Safety Recall Circular

Code: **37E5**

**Subject: 2009-2010 A3, TT and TT Roadster
Equipped with an S tronic Direct Shift Gearbox (DSG)
Reprogram Gearbox (Temperature Sensor Software)**

REVISED
November 2009

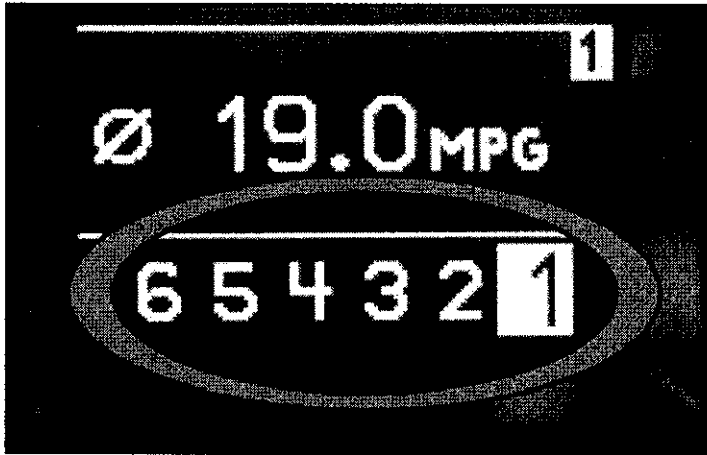
- NEW**
- On MY 2009 vehicles, please inform customer that after the update, the gear display feature in the MFI -arrow- while in Drive "D" or Sport "S" (e.g. 1,2,3,4,5,6) will no longer appear
- This update is not reversible
The feature cannot be turned back on
- **If customer refuses repair**, fax repair order as indicated on SAGA Claim Entry Procedure

Tip: Gear recognition can be observed in the MFI -circle- by placing selector lever into the Tiptronic position
